NAME OF PROJECT: **Hunters Creek Business Park – Lot 1A**; Located at 2021 State Highway 46W; New Braunfels, Texas

TYPE OF PLAN: Request for the Approval of a **Water Pollution Abatement Plan (WPAP)**; 30 Texas Administrative Code (TAC) Chapter 213 Edwards Aquifer

RE: Hunters Creek Business Park - Lot 1A, Water Pollution Abatement Plan (WPAP)

RE: Hunters Creek Business Park - Lot 1A, Water Pollution Abatement Plan (WPAP)

Bioretention (Rain Garden) Cross Section A-A

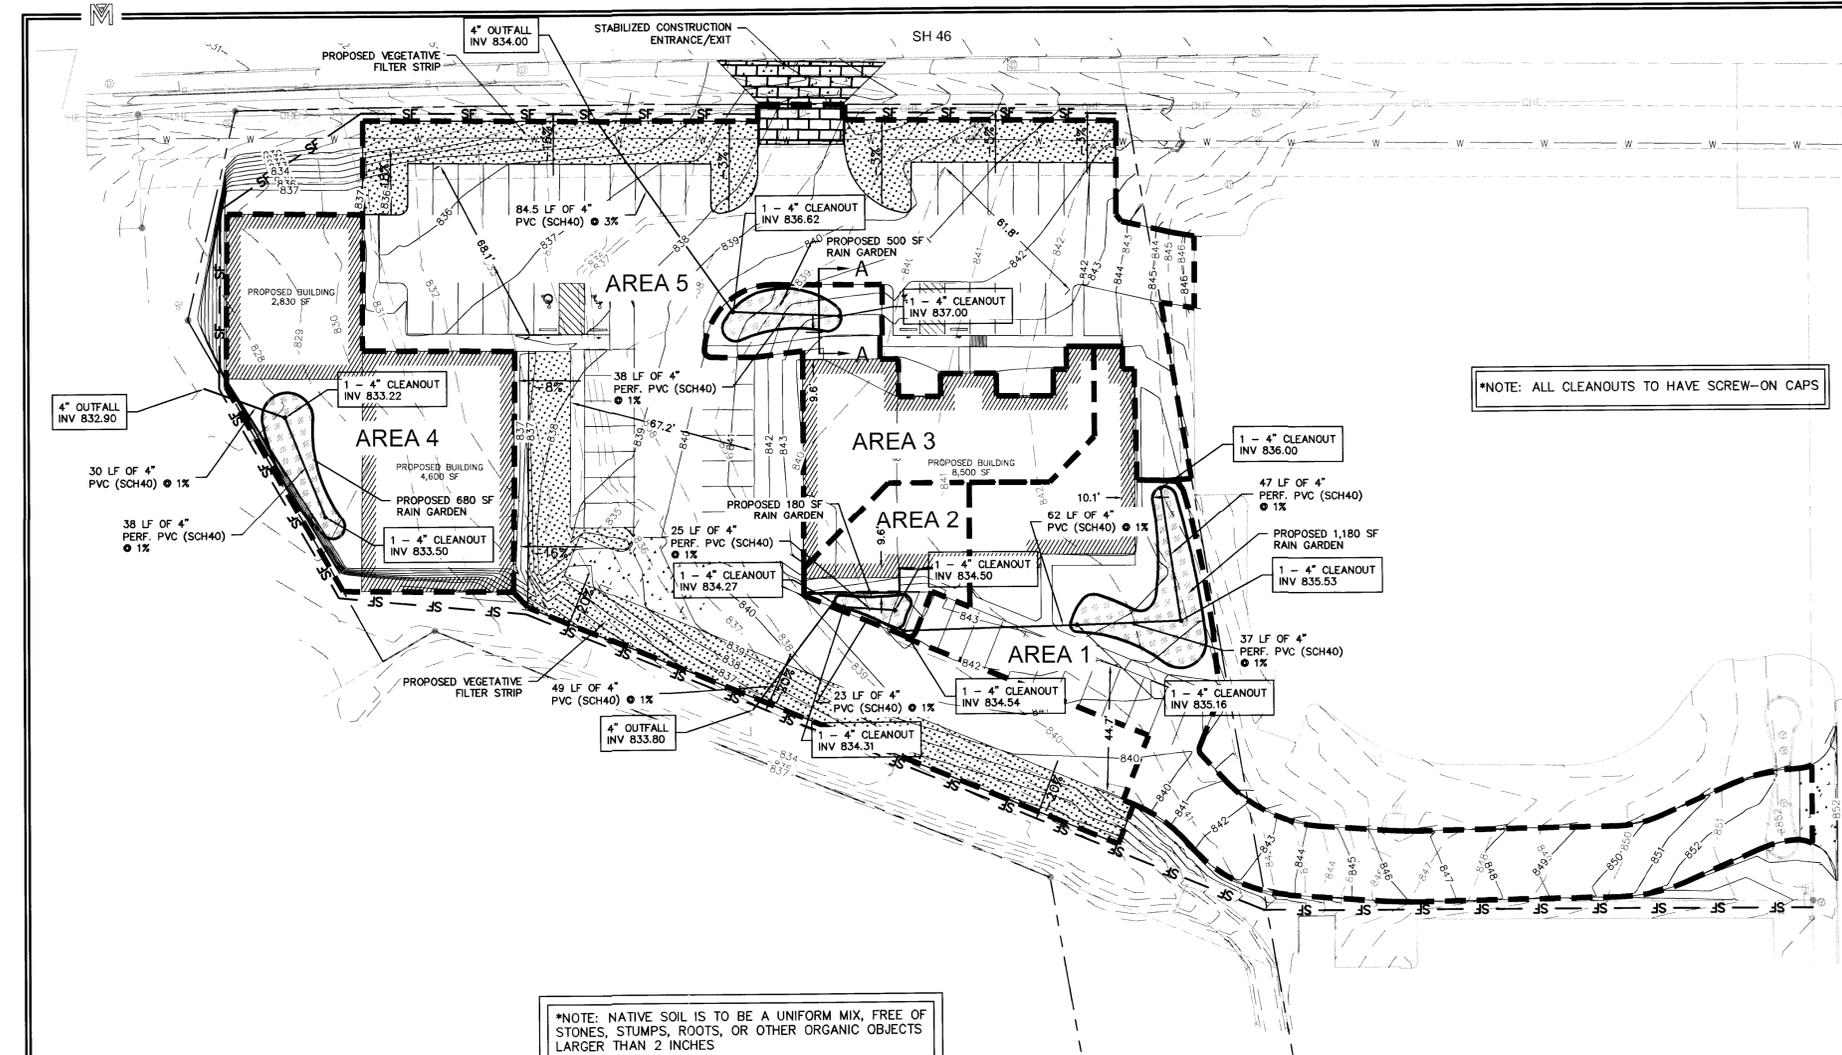
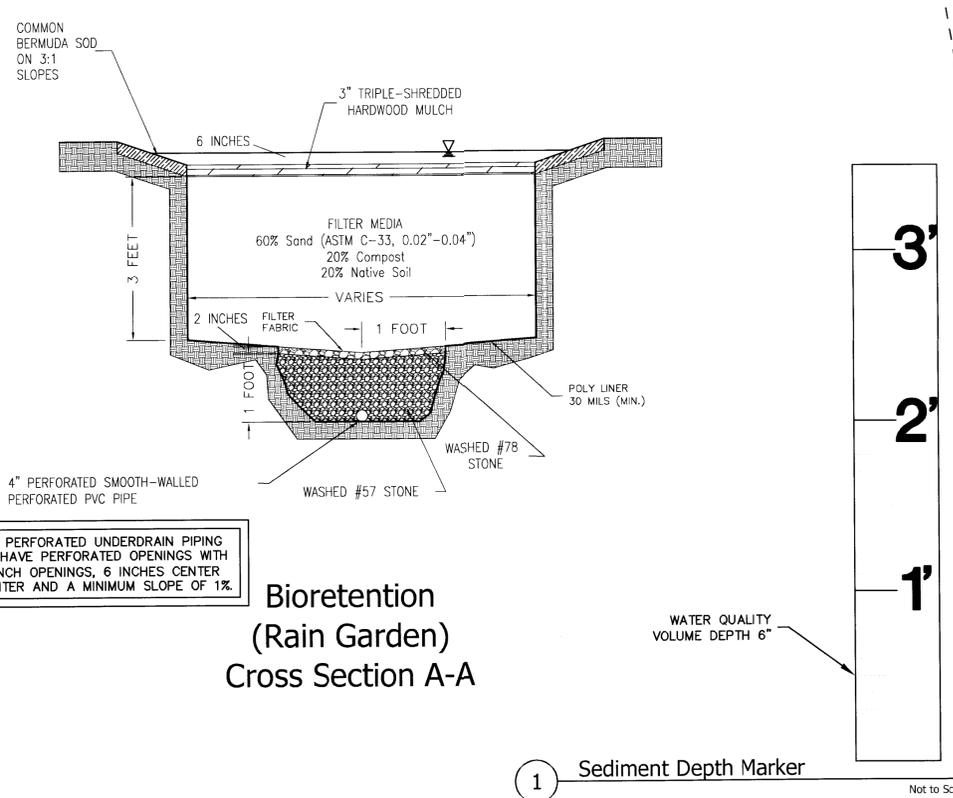
1. The poly liner labeled on the WPAP Site Plan indicates a minimum thickness of 10mils. According to Basin Lining Requirements, a geomembrane liner should have a minimum thickness of 30 mils and be ultraviolet resistant. Please revise the specification.

2. Can you provide confirmation that the native soil in the media is a uniform mix, free of stones, stumps, roots, or other similar objects larger than two inches?

3. *Can you provide confirmation that the underdrain pipes are perforated with 1/4 - 1/2 inch openings, 6 inches center to center; the underdrain slope is 1% minimum and the laterals are spaced at intervals of no more than 10 feet; and the underdrain is not wrapped in filter fabric?*

The note has been revised to specify a 30 mil liner. Please see updated WPAP Site Plan.

The following note has been added to the section detail on the Site Plan: "Note: Native soil is to be a uniform mix, free of stones, stumps, roots, or other organic objects larger than 2 inches". See updated WPAP Site Plan.

The section detail has been updated to show filter fabric between the filter media layer and washed stone. As in-line lateral design is being used due to the narrow design of the rain gardens. The orientation of the single lateral meets the 10' lateral spacing interval. Also, the following note has been added for perforated pipe: "Note: Perforated underdrain piping shall have perforated openings with 1/4 - 1/2 inch openings, 6 inches center to center and a minimum slope of 1%. See updated WPAP Site Plan"

*NOTE: NATIVE SOIL IS TO BE A UNIFORM MIX, FREE OF STONES, STUMPS, ROOTS, OR OTHER ORGANIC OBJECTS LARGER THAN 2 INCHES

Bioretention (Rain Garden) Cross Section A-A

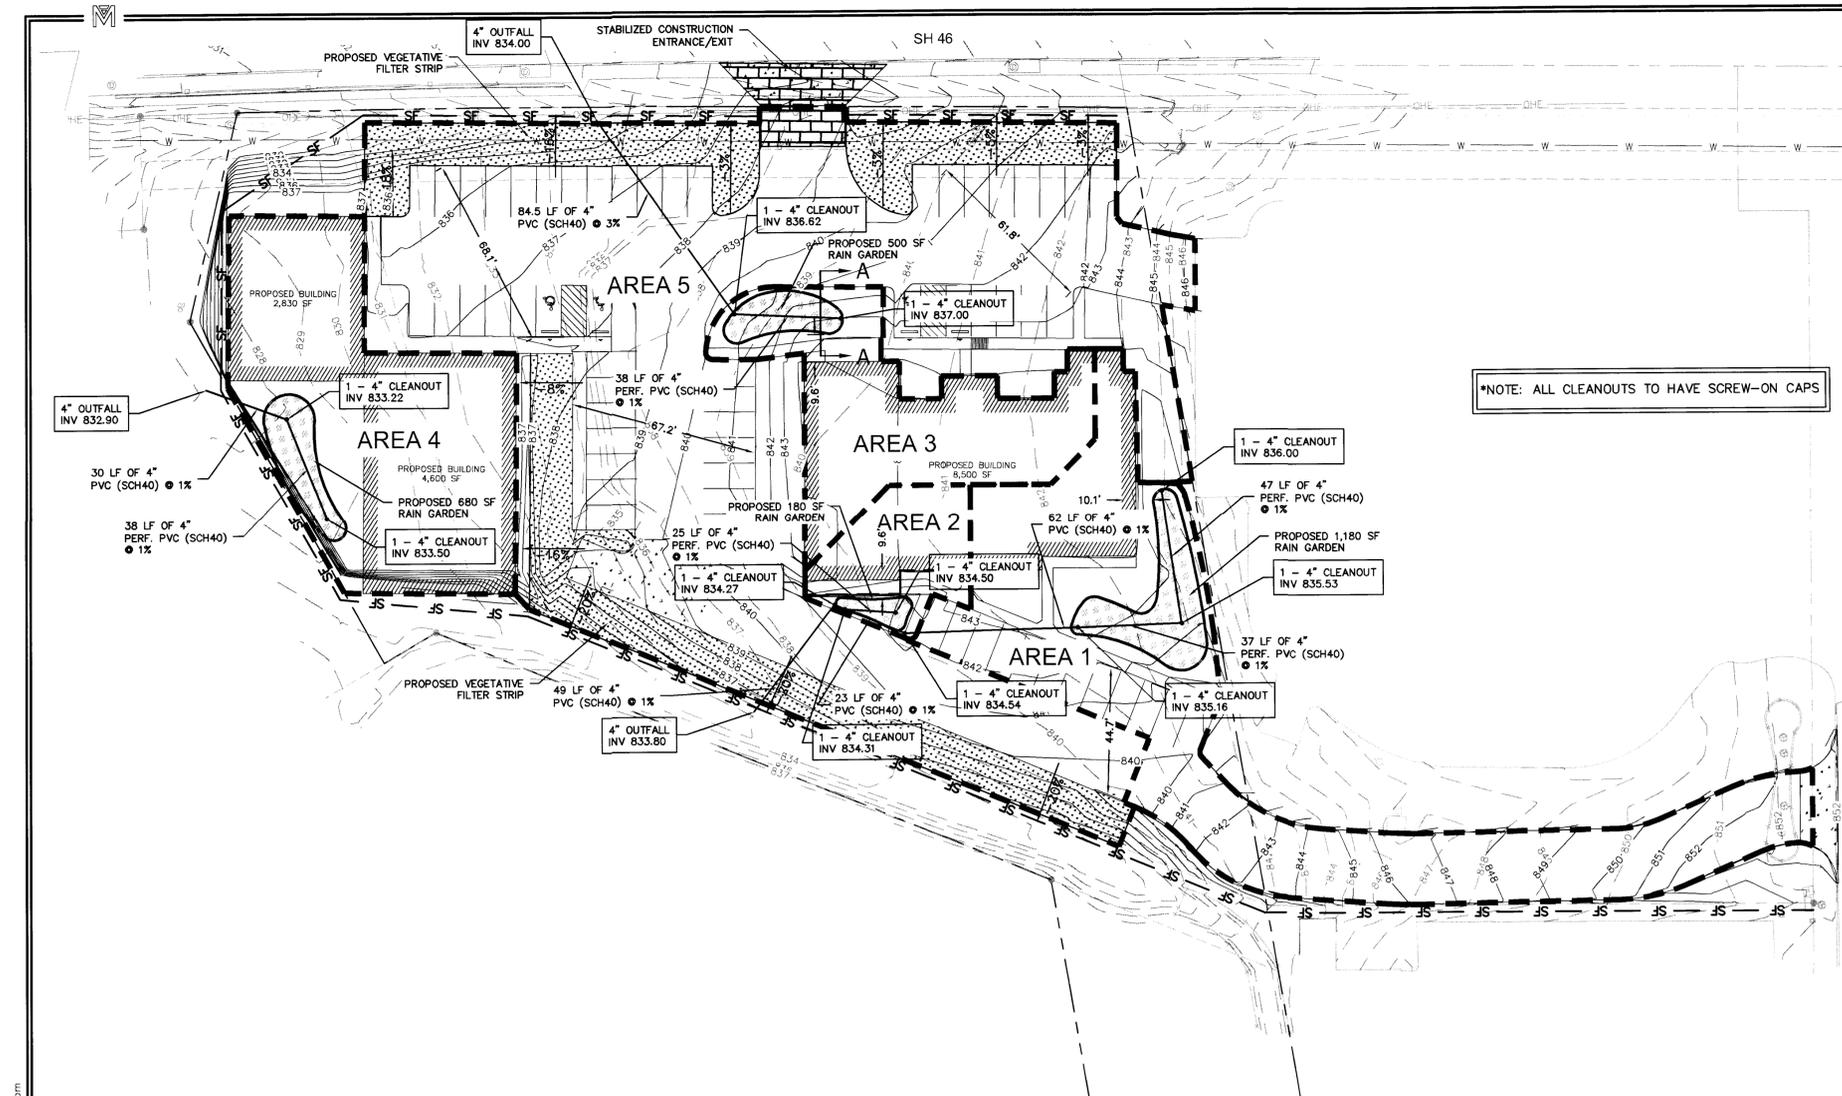
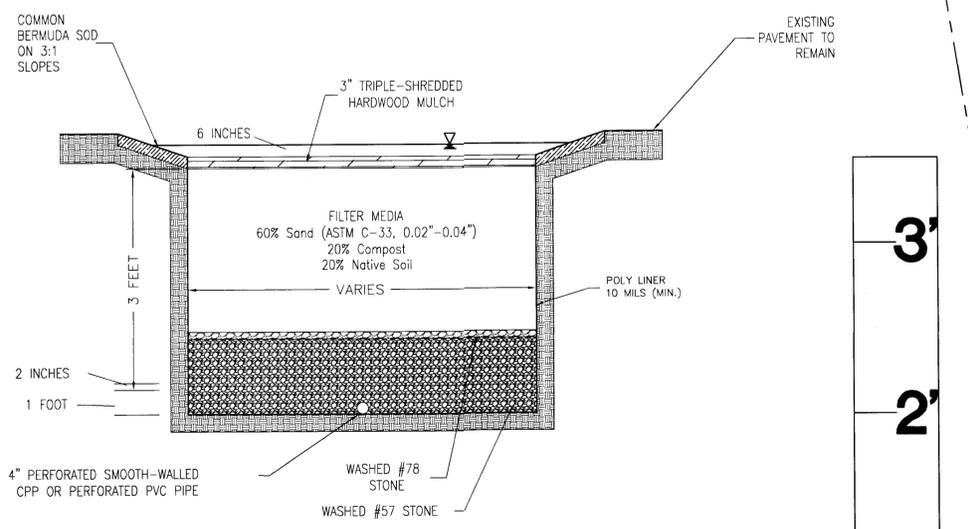
Proposed Structural BMP plans and specifications: The four (4) Bioretention (Rain Garden) systems are to be designed according to RG 348 Edwards Aquifer Rules (3.2.6 and 3.4.8 Bioretention). Please address the following:

- 1. Will a fixed vertical sediment depth marker be installed in each proposed bioretention (rain garden)? Reference 3.4.8 Bioretention Water Quality Volume*
Yes, detail has been added to the plans.

2. *What is the ASTM and grain size of the sand being used in the filter media?
Reference 3.4.8 Bioretention*
Additional information has been added to the section detail on the WPAP Site Plan.

3. *Will each proposed bioretention (rain garden) have a cleanout access for each underdrain? Reference 3.4.8 Bioretention, Underdrains*
Yes, additional detail has been added showing underdrain piping. See updated WPAP Site Plan.

4. *The proposed bioretention (rain garden) for the drainage area 1 is designed to be 1,180 square feet. Will there be more than one main collector pipe with lateral branch pipes (underdrain)? Reference 3.4.8 Bioretention, Underdrains*
Because the bioretention area is narrow a single perforated pipe along the center of the basin will provide adequate drainage per the 10' spacing requirement. This is the method used for all 4 of the proposed basins. See updated WPAP Site Plan.

5. *The bioretention (rain garden) located in drainage area 2 is running alongside the proposed 8,500 square feet building. There is a required 5 foot setback to foundation slab and the site plan indicates less than 5 feet. Reference 3.4.8 Bioretention, Setbacks*
The WPAP Site Plan has been updated to allow for the necessary spacing between the building foundation and bioretention area.

6. *Will each proposed bioretention (rain garden) have the required filter fabric liner between the in-situ soils and the planting soil medium? The liner is required if a bioretention is constructed in the Recharge Zone. Reference 3.4.8 Bioretention, Liners.*
A 10 mil Poly Liner will be placed between the in situ soil and filter media. The cross section detail has been updated. See updated WPAP Site Plan.
